1 **ADDENDUM NO. 1**  
2 ISSUE DATE: August 22, 2019

3  
4  
5 RE: **BASEBALL FIELD RENOVATIONS**  
6 **UNIVERSITY OF WISCONSIN – STEVENS POINT**  
7 **STEVENS POINT, WISCONSIN**  
8 UWSA Project No. **K-19-001**  
9

11  
12 FROM: **SmithGroup**  
13 **44 East Mifflin Street, Suite 500**  
14 **Madison, Wisconsin 53703**  
15

24 This Addendum consists of (1) one page and the attached documents, **Specification Section 02 32 00 –**  
25 **Geotechnical Investigation, and full-size Drawings CS100, CS101, CS102 and CS500.**  
26

UWSA Number	K-19-001
Set Type	BD
Date issued	07/30/2019
Sheet Number	CS100

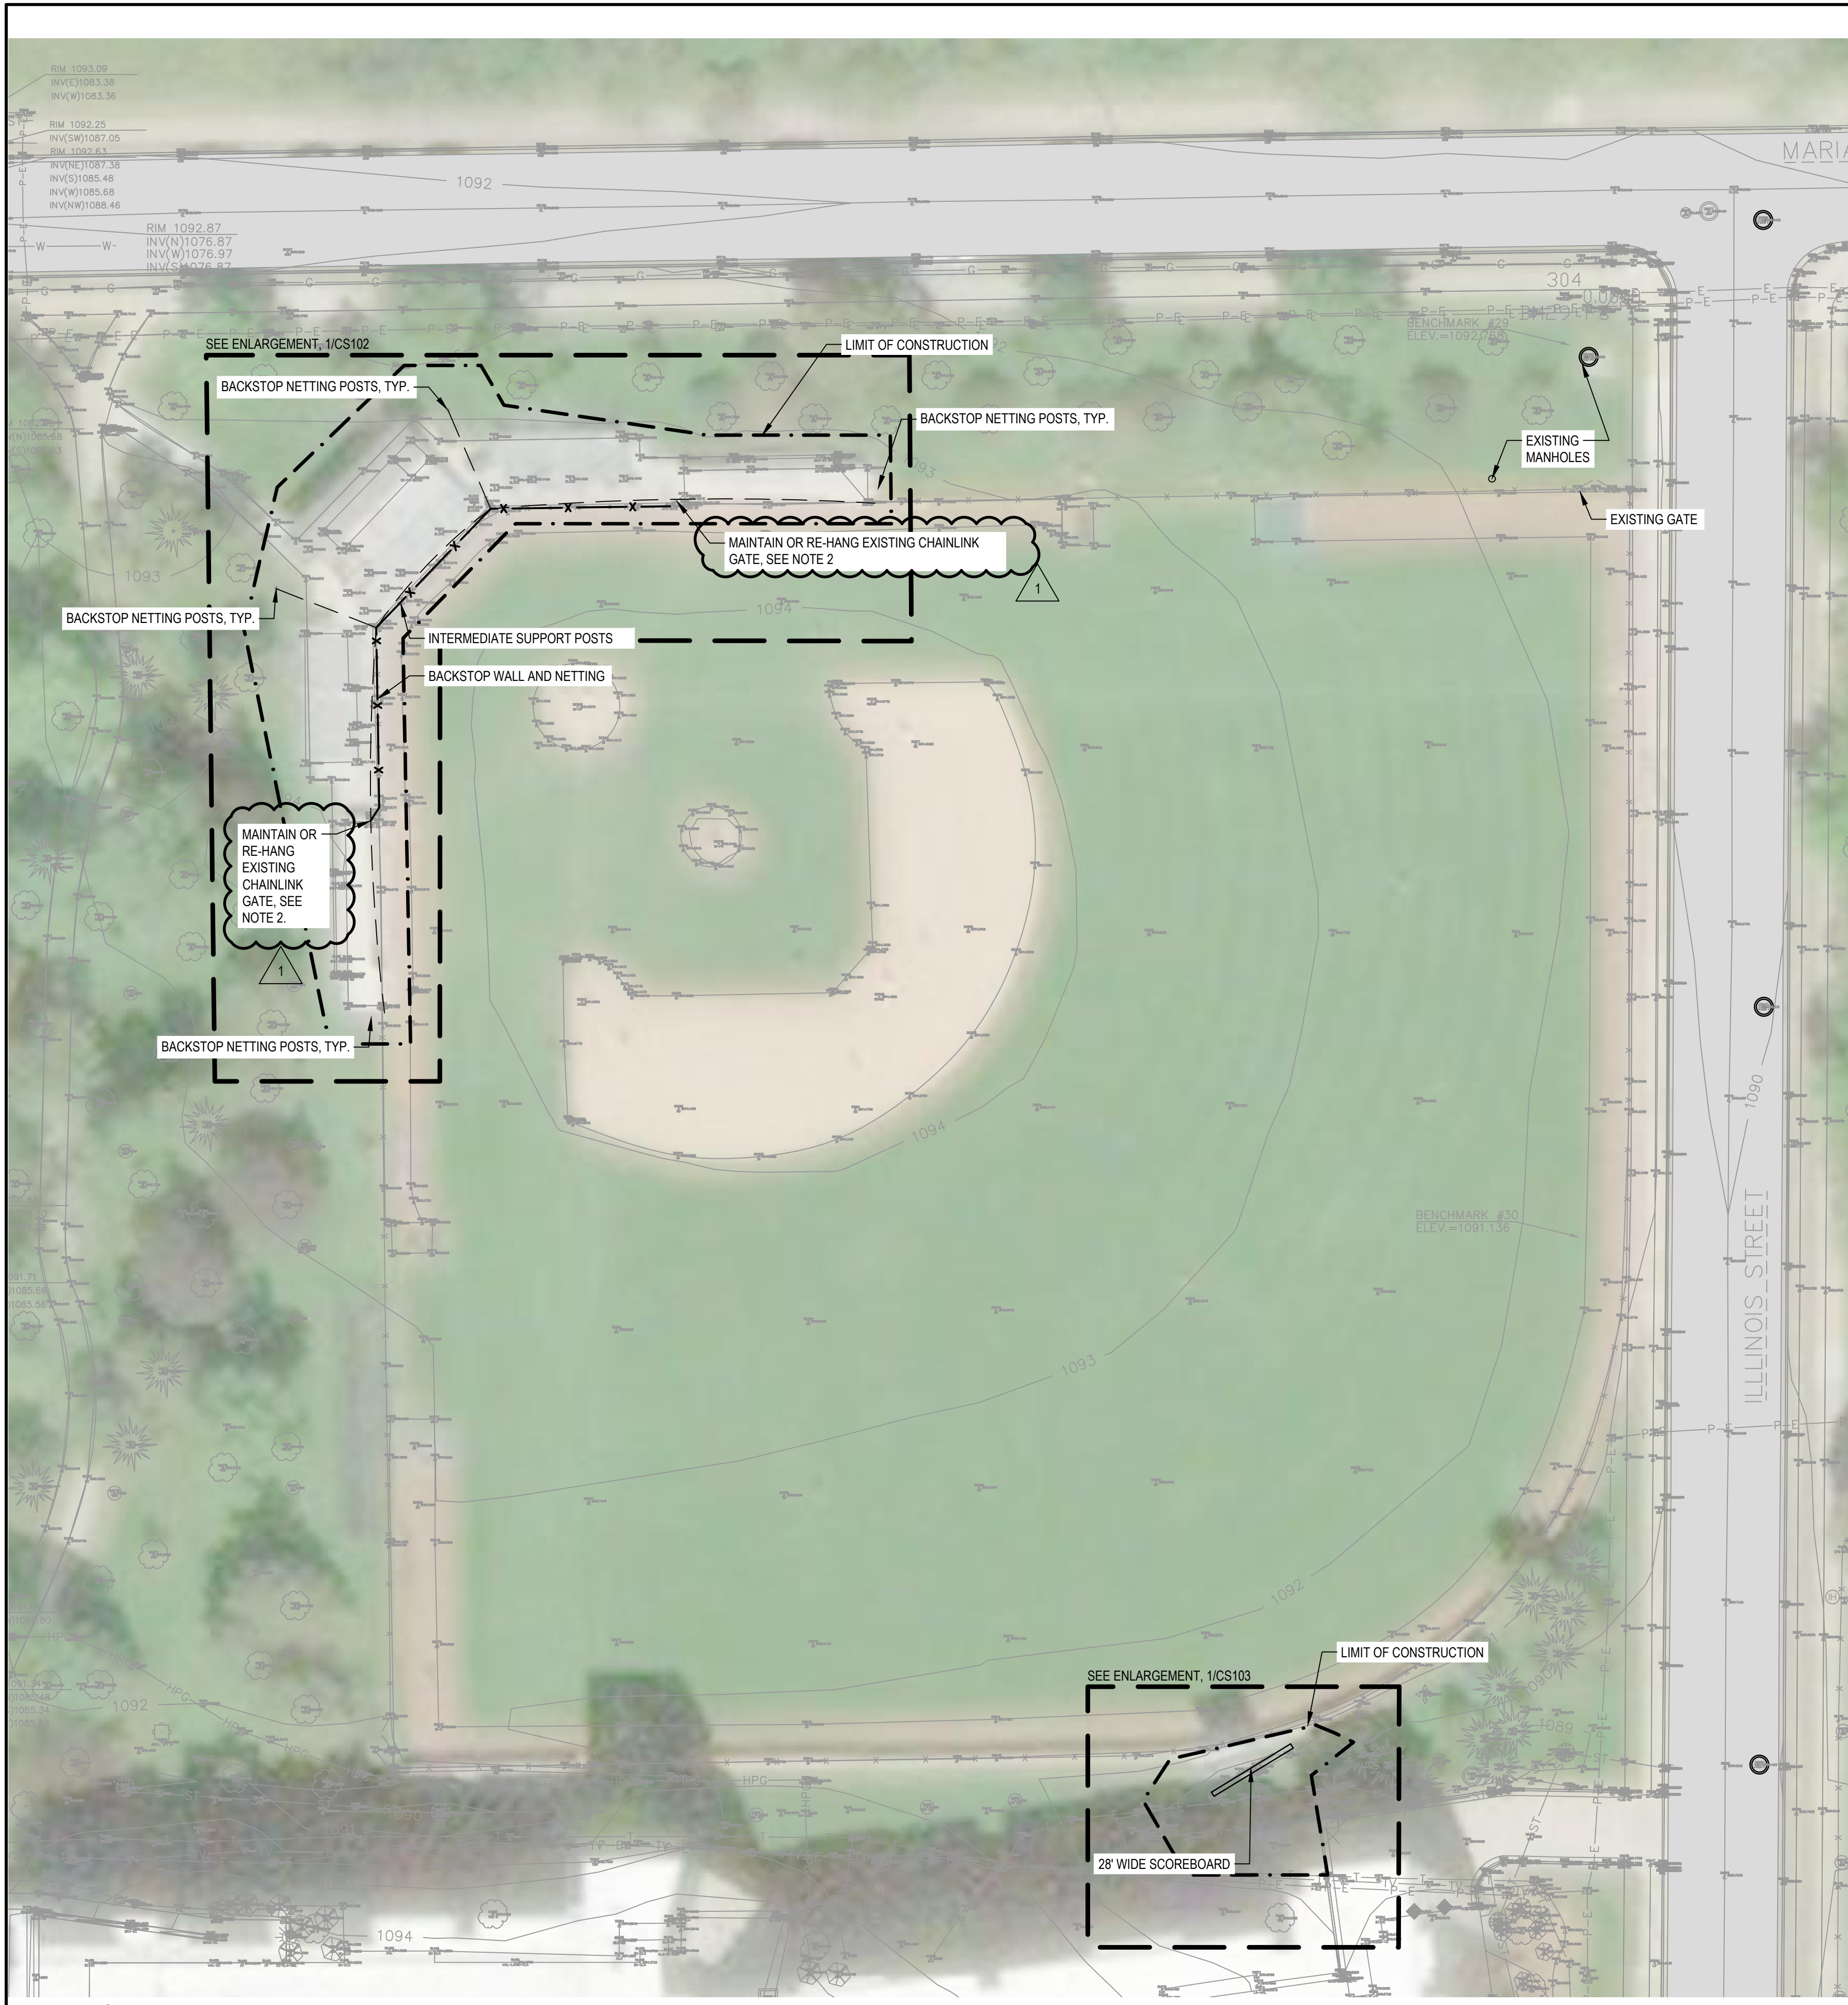
- 35 3. Drawing CS100 – OVERALL SITE PLAN: Delete Drawing CS100 and replace with revised CS100,  
36 attached.  
37  
38 4. Drawing CS101 – DEMOLITION AND EROSION CONTROL PLAN: Delete Drawing CS101 and  
39 replace with revised CS101, attached.  
40  
41 5. Drawing CS102 – LAYOUT PLAN ENLARGEMENT AND DETAILS: Delete Drawing CS102 and  
42 replace with revised CS102, attached.  
43  
44 6. Drawing CS500 – SITE DETAILS – SITE PREPARATION: Delete Drawing CS500 and replace with  
45 revised CS500, attached.  
46

**3 SCOREBOARD MOCKUP** NOT TO SCALE

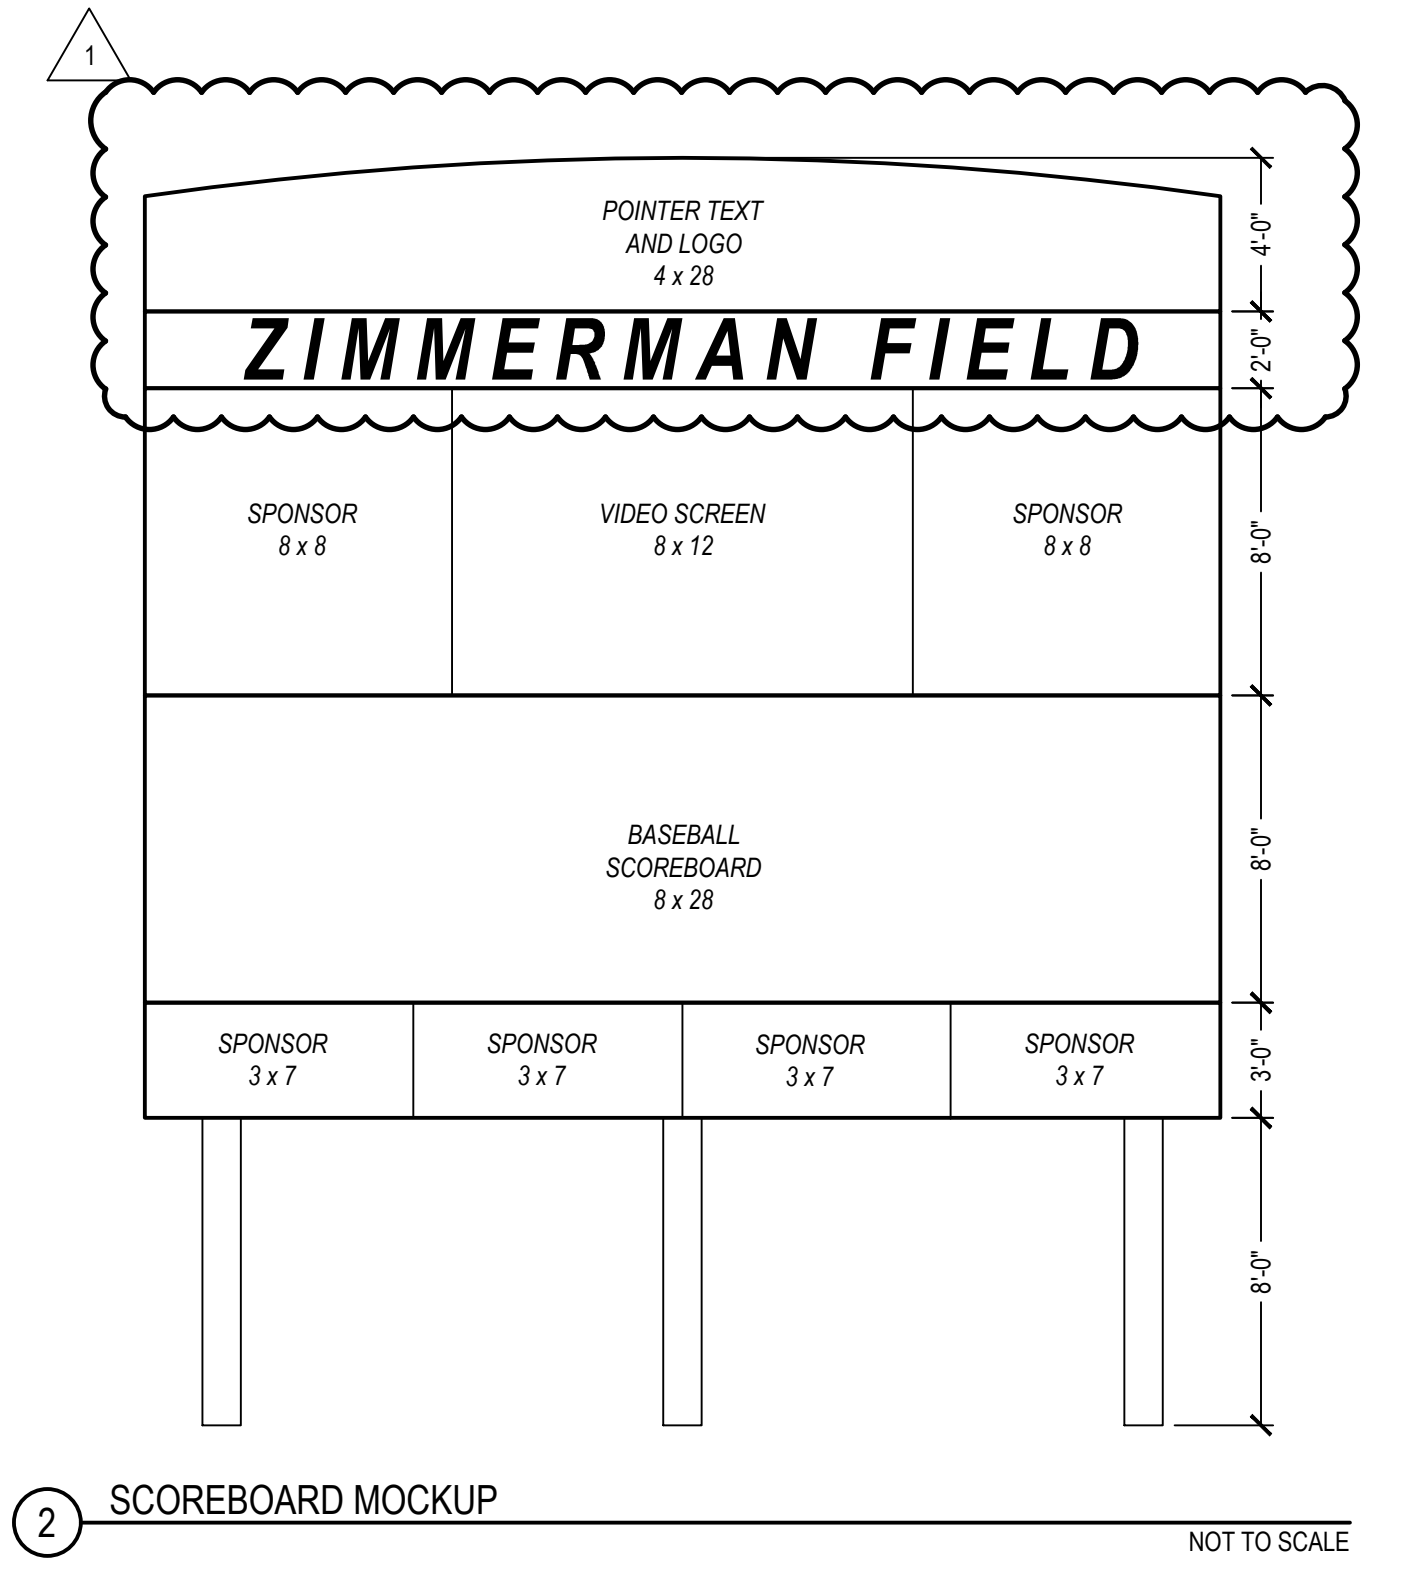
- 28 1. Page 3, line 48, ADD: “Where Hot Dipped Galvanized Assembly Hardware is identified, use of Zinc-  
29 plated hardware will also be acceptable.”  
30  
31 2. Page 4, line 6, ADD: “2. Top: 2’ x 28’ Text “ZIMMERMAN FIELD”  
32
